APPEAL SUMMARY

Appeal ID: 20771	Project Address: 200 NW Royal Blvd, Lot #2
Hearing Date: 8/21/19	Appellant Name: Robert Oshatz
Case No.: B-007	Appellant Phone: 5036354243
Appeal Type: Building	Plans Examiner/Inspector: Jason Butler-Brown
Project Type: residential	Stories: 3 Occupancy: R Construction Type: V-B
Building/Business Name: RHO LLC	Fire Sprinklers: No
Appeal Involves: Erection of a new structure	LUR or Permit Application No.: 06-109711-LU
Plan Submitted Option: pdf [File 1] [File 2]	Proposed use: Single family residence

Code Section R302

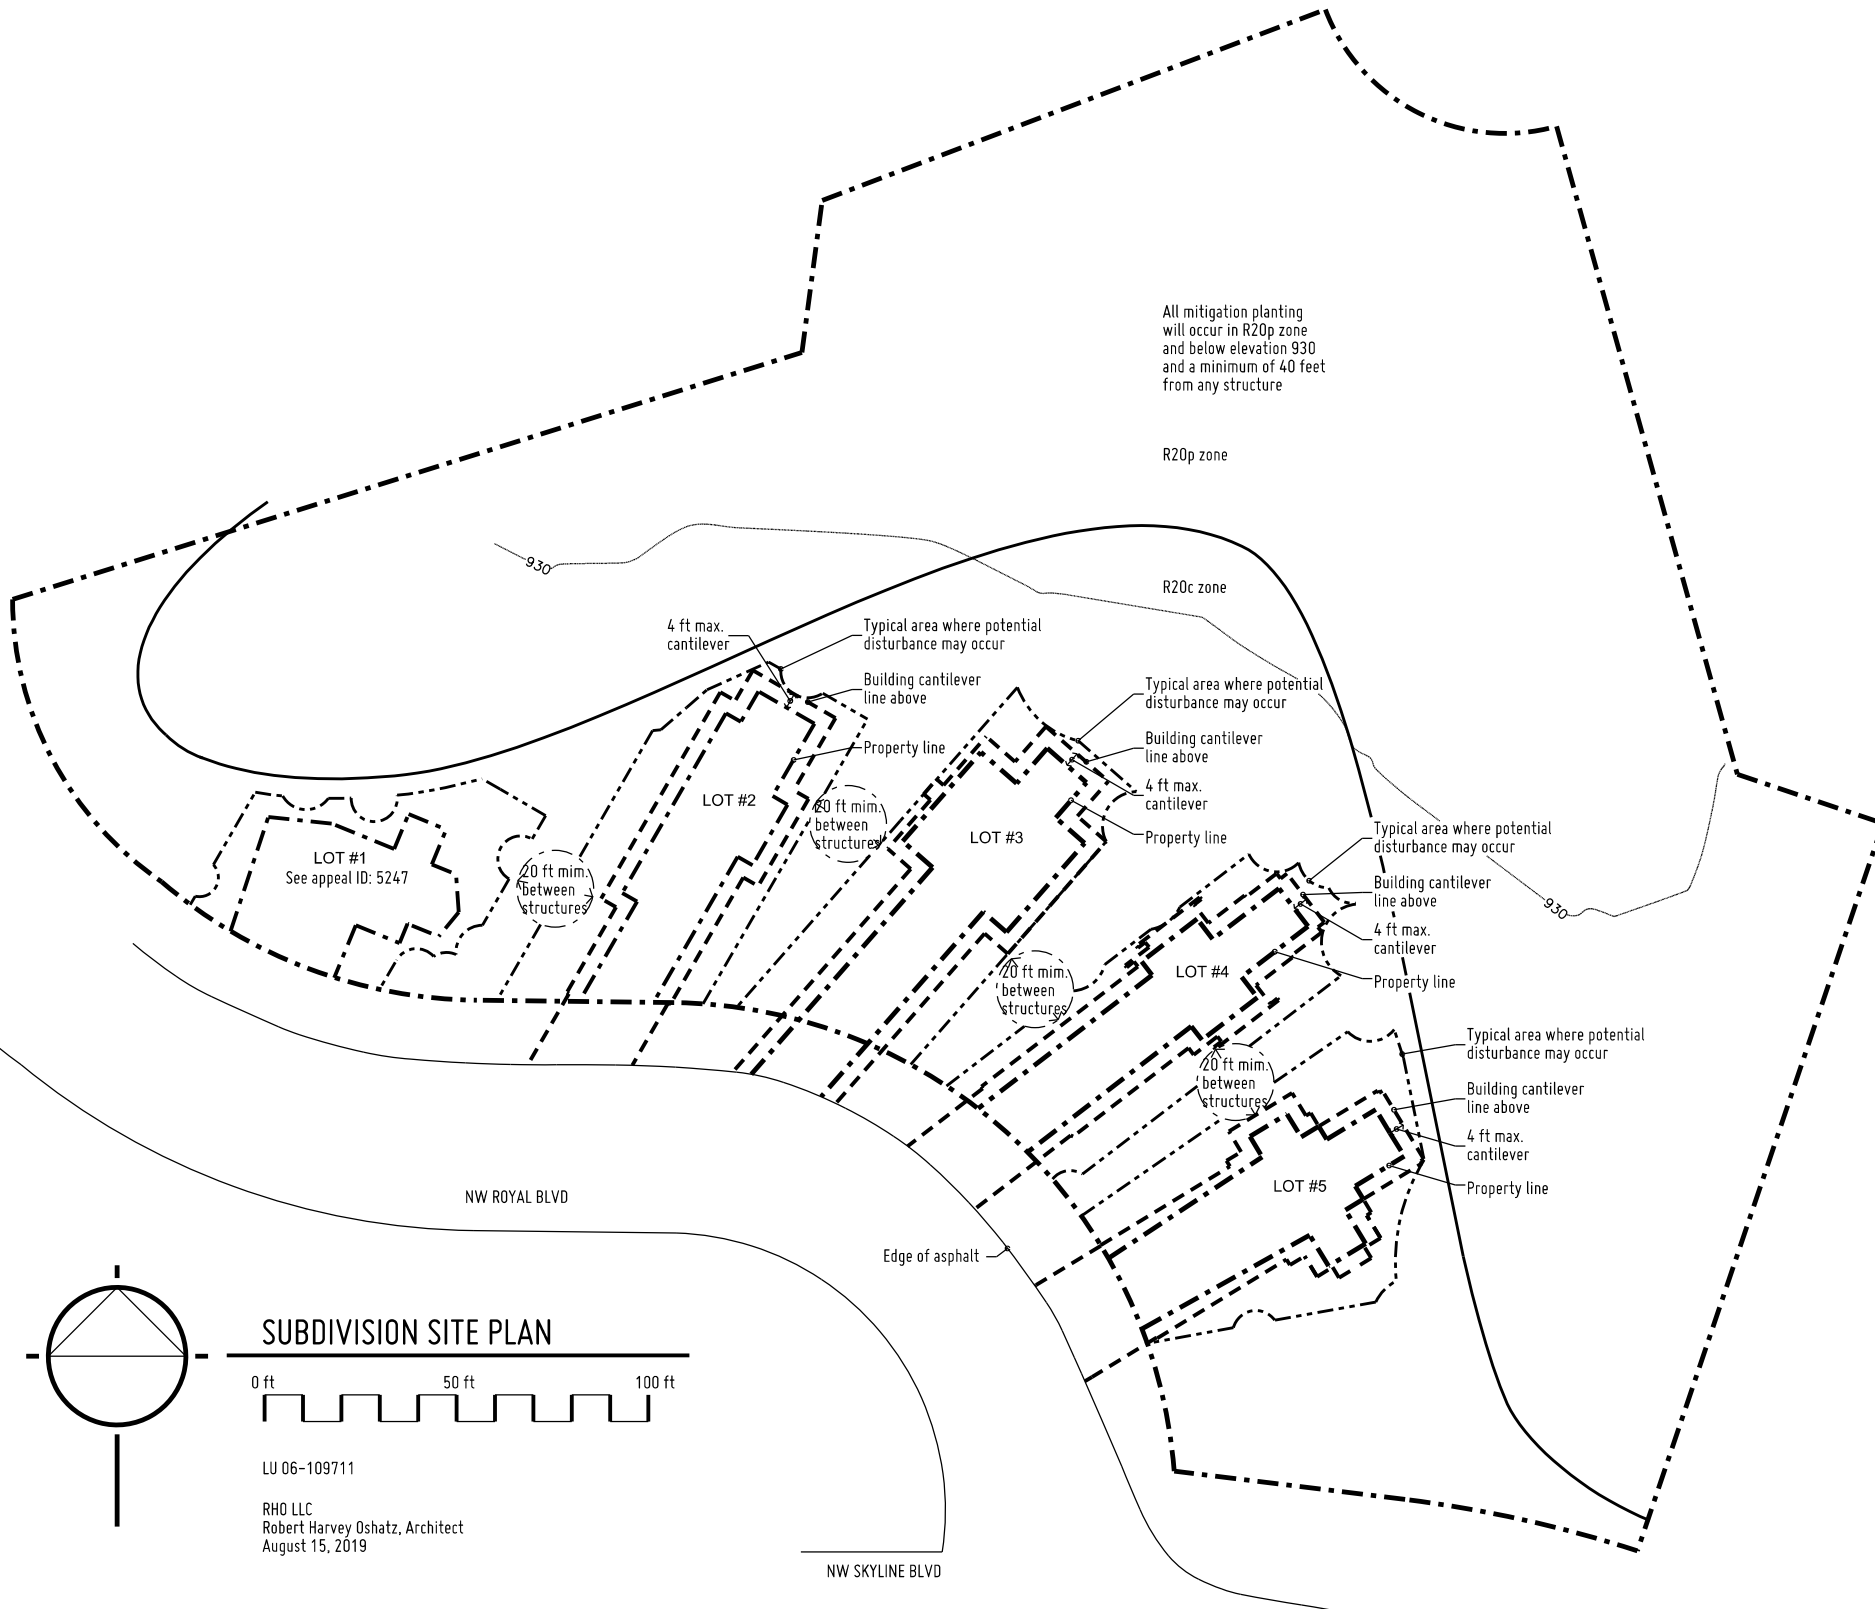
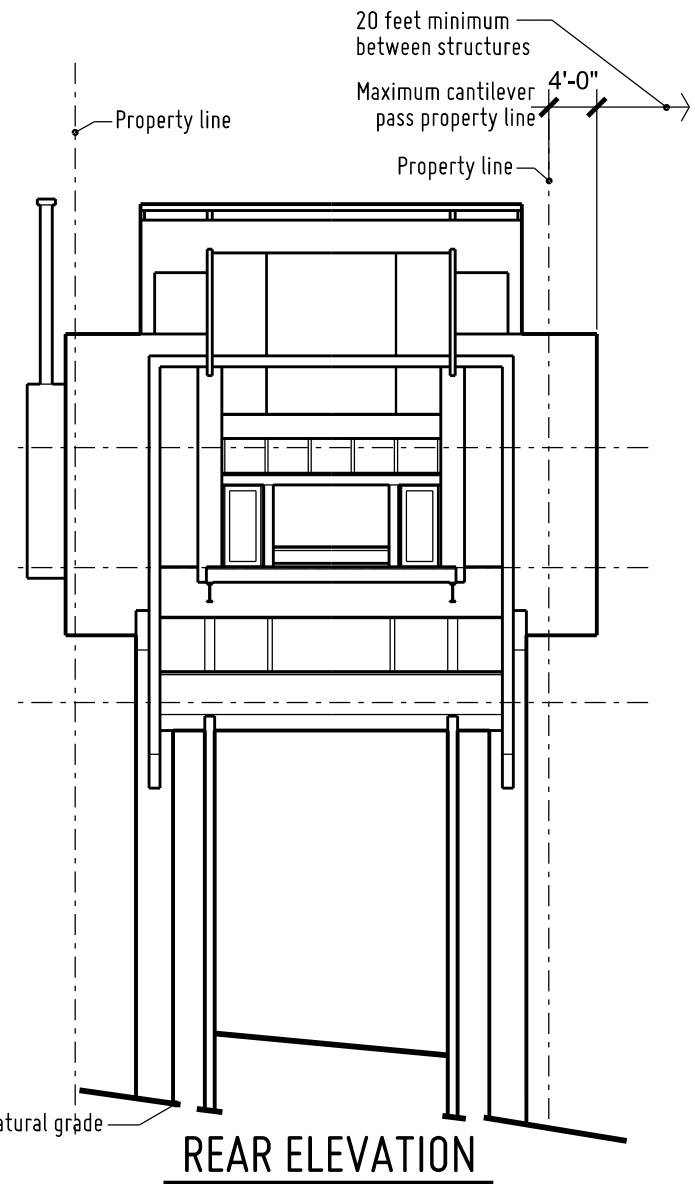
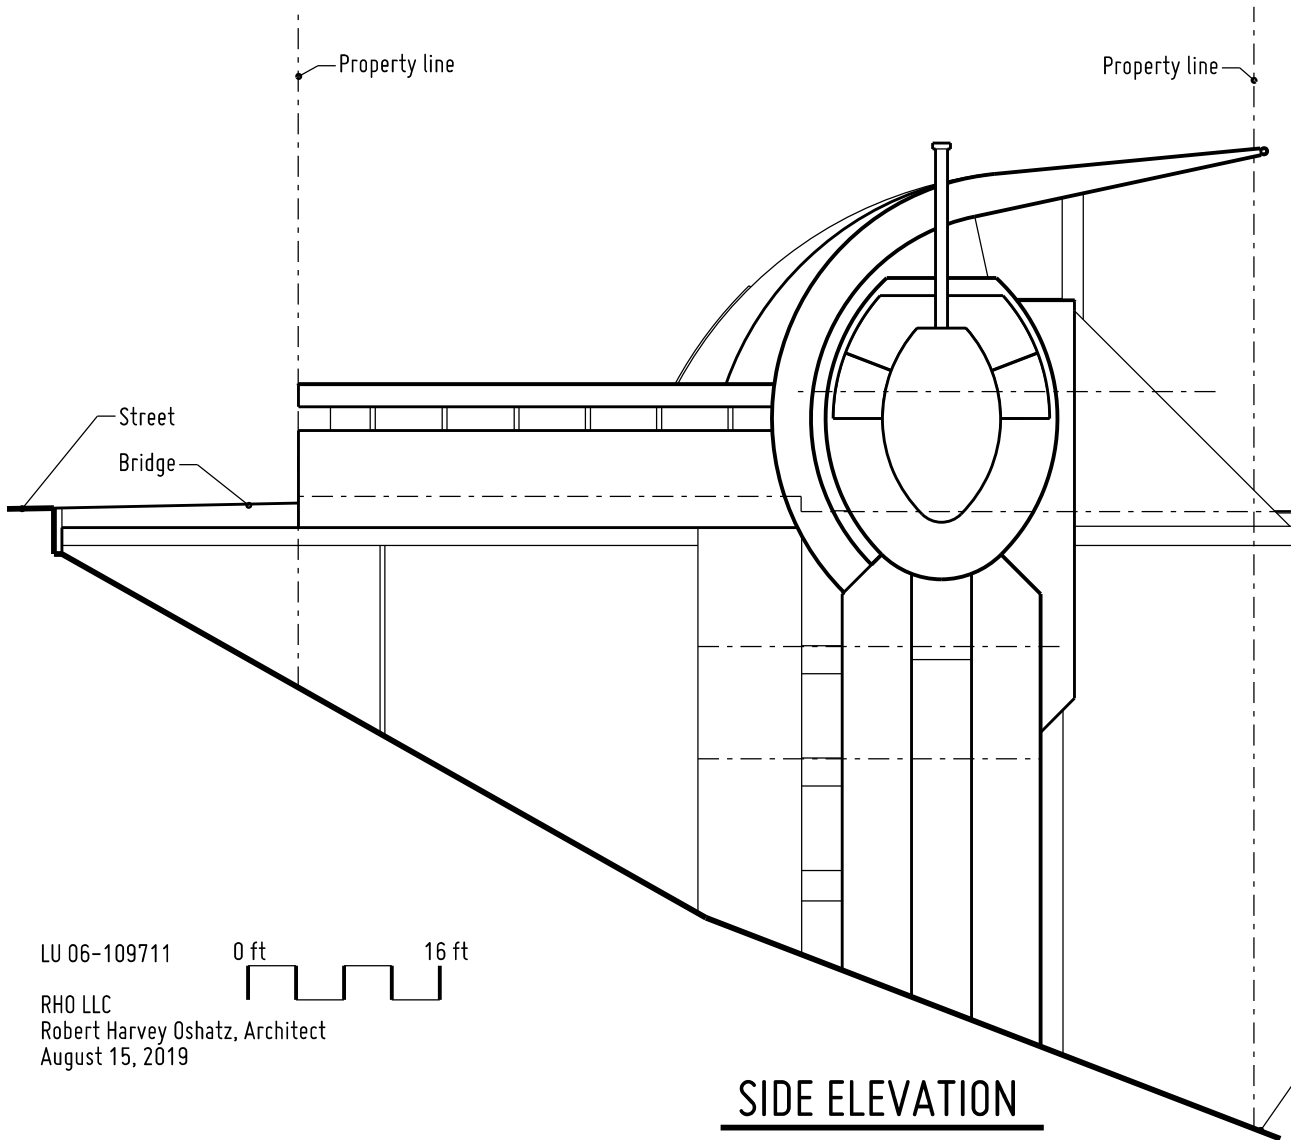
Requires Openings are not allowed less than 3 feet from property line.

Proposed Design Hearing Officer Ian Simpson approved the subdivision on Lot 7 Block5, Royal on March 28, 2007 (see LU 06-109711). In June of 2008, a similar appeal request was approved for Lot #1 of this subdivision (see Appeal ID: 5247).

At this time, I am applying for a building code appeal on Lot #2 to cantilever as shown in the attach drawings into the subdivision private common green area. The steeply sloping downhill site requires steel H-piling supports. Horizontally at street level and supported by the piling will be a steel and wood bridge. The house will be built on top, hung from and cantilever out from the bridge. The cantilevering in a cantilever easement area beyond the individual property lines (see reason for alternate) will be of conventional wood frame construction supported by steel and engineered lumber beams. The finish exterior walls and roof will be of sheet-metal, wood and stucco siding.

Reason for alternative Code Guides, OSSC/7#7 and OSSC/32#1 are concerned with public and fire safety. It allows a 4 ft cantilever into common green space but limits total area to 50% of its area into that cantilever space. In this situation, the house on Lot #2 after its cantilevering will be at least 20 feet away from the future finish house on Lot #1 and lot #3. This house is in a R20 zone which normally requires a separation of 20 feet between houses. This appeal will maintain that separation. In addition being in an area requiring 90% forest canopy, to protect against fire the exterior walls and roof (as part of the conditions of approval for the subdivision all roofs shall be Class B roofing materials) will be of

Section R302.1 of the 2005 Oregon Residential Specialty Code is concerned with public safety. It requires that openings are not permitted less than 3 feet from a property line. Essentially this results in a separation of openings between structures of at least 6 feet to prevent fire spreading. In this appeal, for Lot #2 will be at least 20 feet away from any future structure on Lot #1 and Lot #3 (as required by the subdivision approval). This is greatly exceeding the 6 feet suggested by R302.1. Thus, the design follows the intent of the code and more than satisfies it.

I feel code guide OSSC/32/#1 should not apply in this case. In the past it has been targeted for cantilevering into public common areas that is used by the public. This is a case where the structure is cantilevering into its own privately not open to the public green space. When the subdivision is look at with its private common green space (which is not open to use by the public and since the site is steeply sloping and the structures are not design for their occupants to use the private common green space) in essence the house is meeting the concerns of a residence built in a R20 zone. In reality except to meet zoning requirements of an environmentally sensitive site the property lines are imaginary (in essence the planning department is saying this by going along with the concept of cantilevering over the property lines and requiring the residence to be a minimum of 2,000 sf).

The cantilever deck which will be constructed of steel beams, 4x14 joist and 2x6 outdoor decking; the roof will be Class B materials, the walls are cad in sheet-metal, wood and stucco and soffits will be 5/8" fire rated gypsum board; making the structure at least as safe as any other residence in the neighbor. In addition, I am willing to work with the Fire Marshall's office to mitigate any of their concerns.

Openings in exterior walls at property line: Hold for additional information.
Appellant may contact John Butler (503 823-7339) with questions.
